Staff Report

Item: “Dove Landing” Planned Unit Development (ANX 2020-03)

ANX 2020-03: Analyses & Findings

13.1

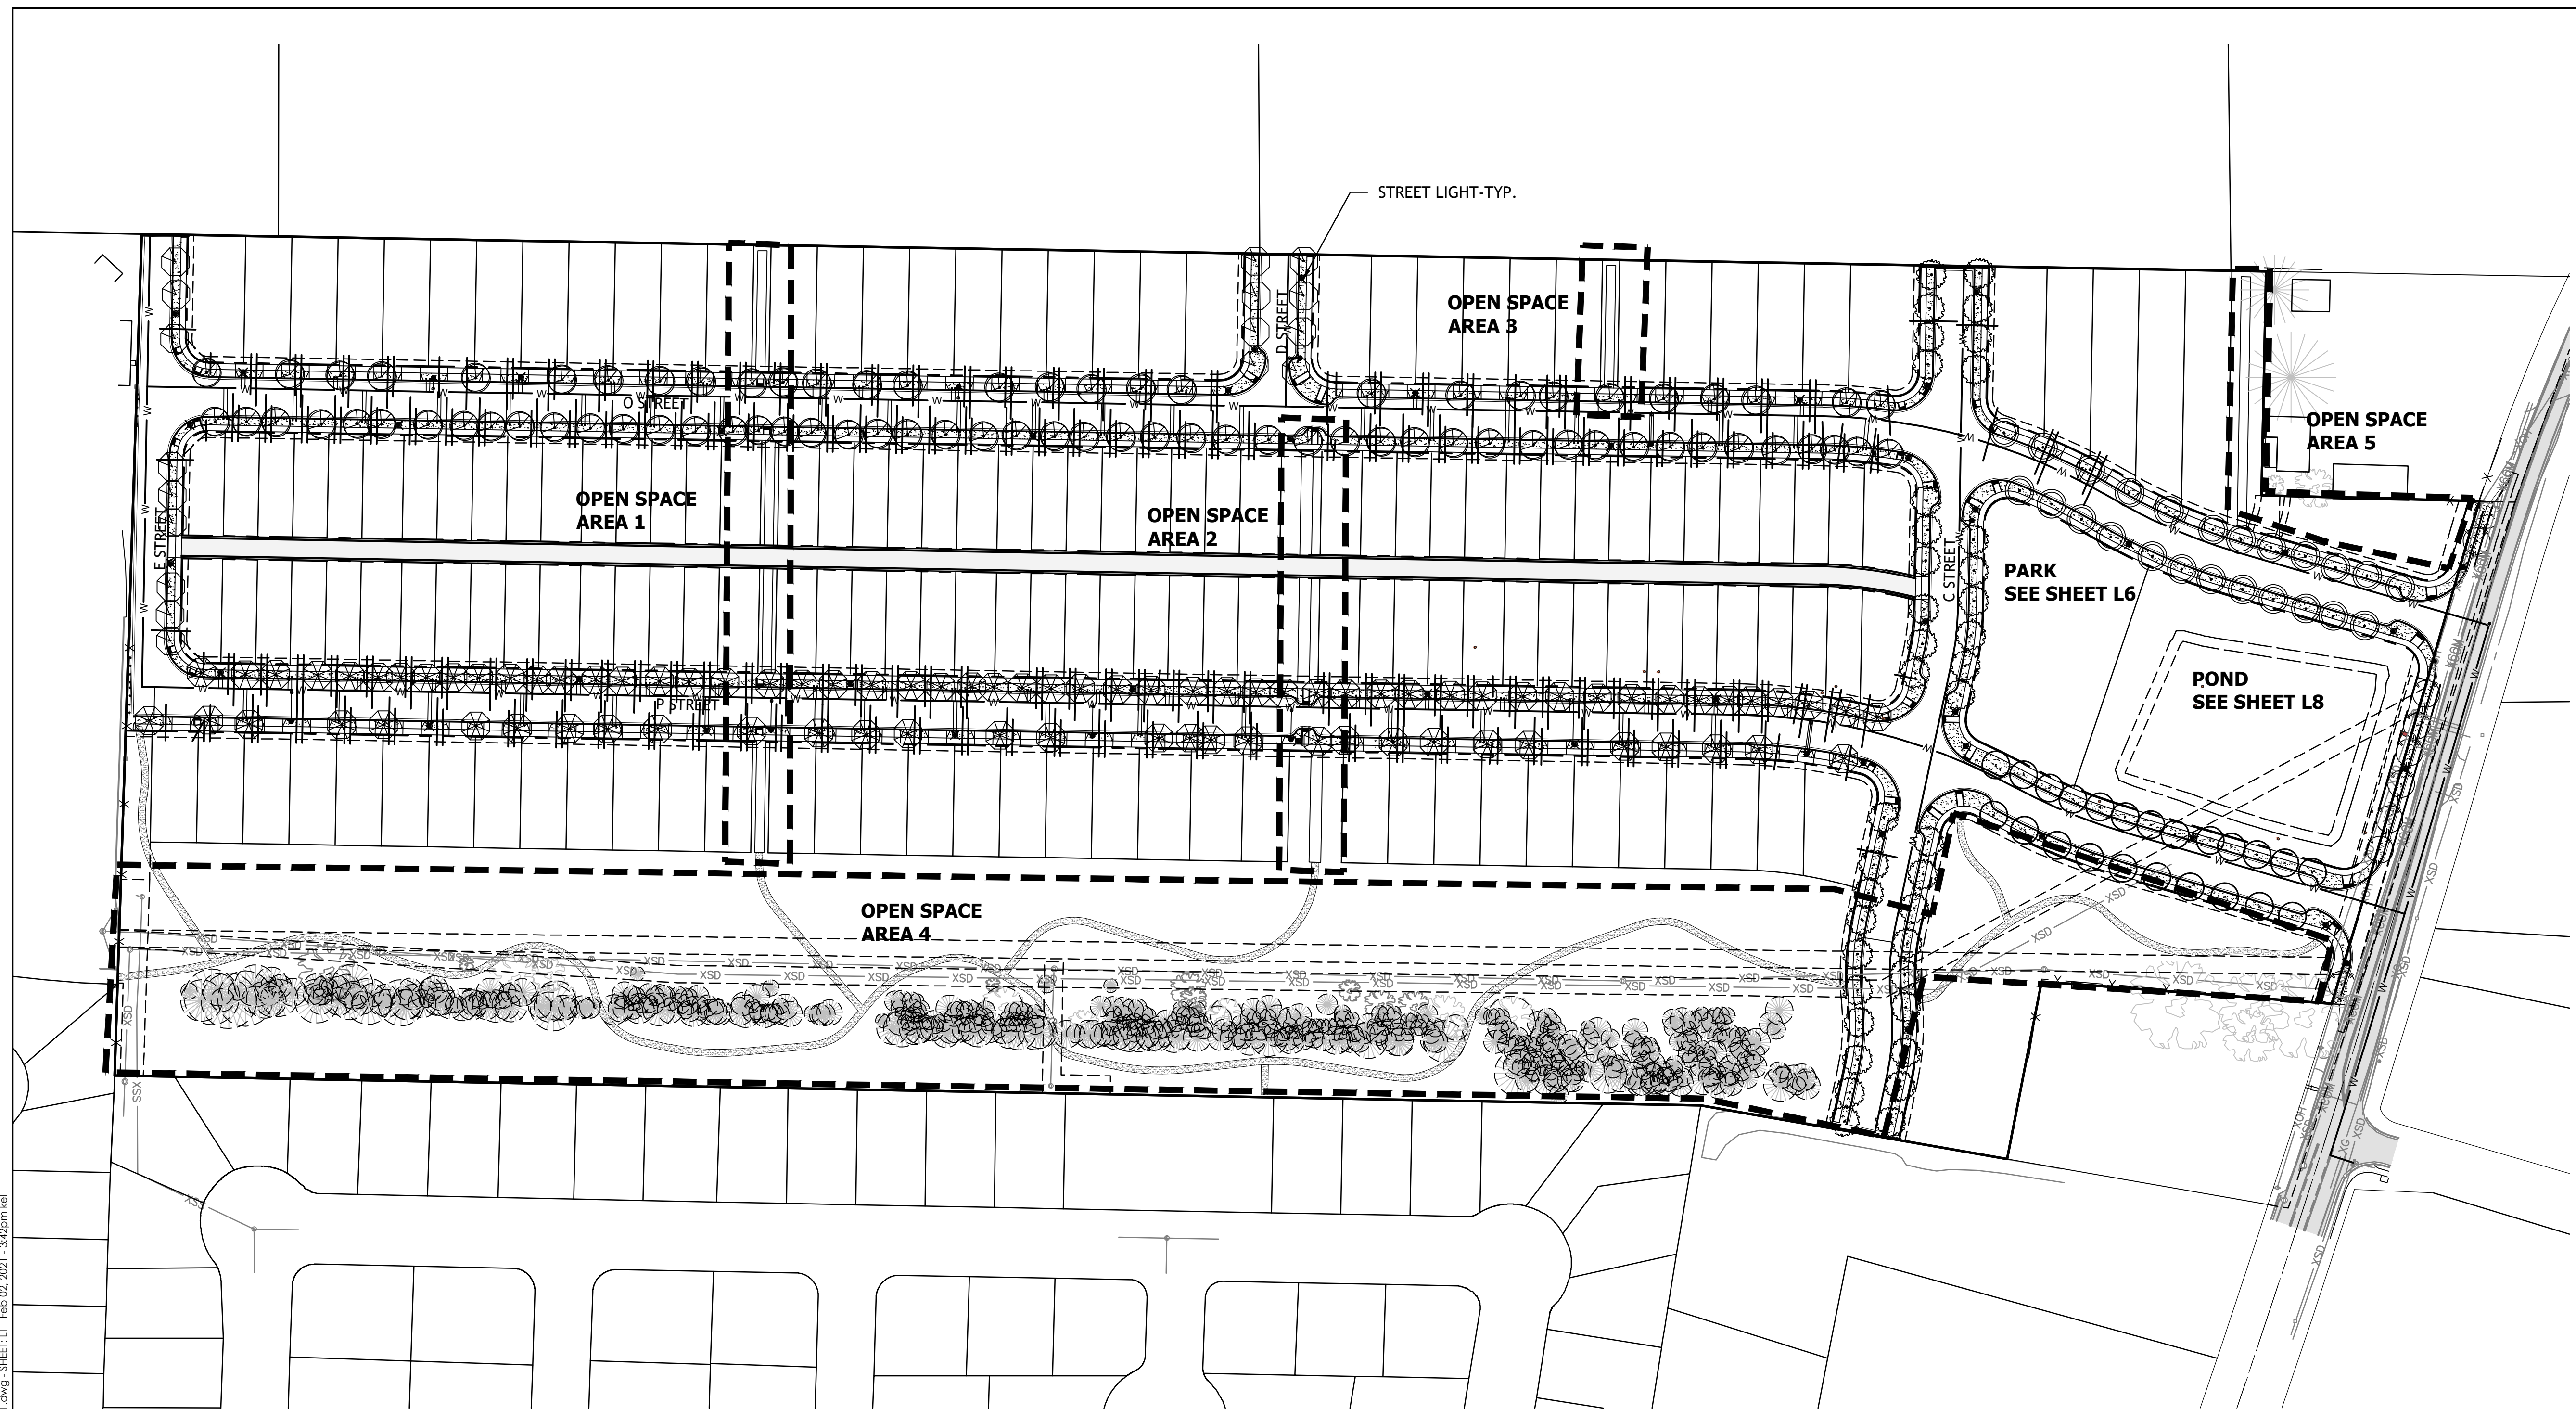
2. SW: Development shall preserve the trees that land use review Sheet 13.1 illustrates to be retained and shall partially retain those that the supplemental arborist memo of January 6, 2021 submitted January 15 summarizes to retain by creating snags out of trees 70522 and 70523 by reducing their heights to max 15 ft and girdling the trunks. Any removal would trigger a tree removal fee / preservation fee in-lieu per Attachment 206.
